MEMORANDUM

SUBJECT: SPECIAL PROJECTS
UNIONVILLE MAIN STREET STREETSCAPE – DETAILED DESIGN STAGE-
LIGHT POLES

Project: Unionville Main Street Streetscape – Detailed Design Stage

Issue: Selection of Street Light Poles

WiFi Box

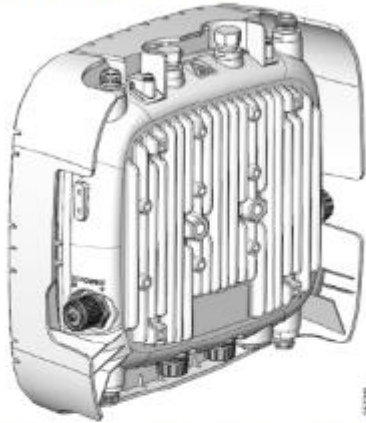
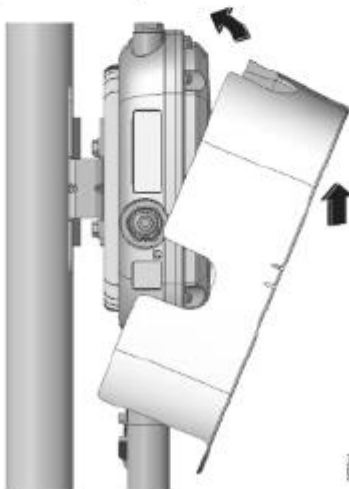
- See proposed infrastructure depicted on the street light pole illustration.
- Size of Unit: 259mm x 233mm x 81mm (10.2in x 9.2in x 3.2in)
- Staff indicated that: 1) prefer not to have these units attached to the light poles at all as they do intrude on the historic character of the pole; and 2) if these units are to be installed, the revised unit seem less intrusive especially as there will be a banner next to it. Colour should match the pole (black). This design uses an AP with an internal antenna to eliminate a second unit on the backside (a previous concept that was reviewed) and the CISCO Access Point being used does come with an optional cover that can be painted. This is much less obtrusive than the white units staff initially reviewed. If considered acceptable, the consultant will have this finalized and included in their specifications for lighting (wifi equipment would come after the fact but would be accommodated on the pole).
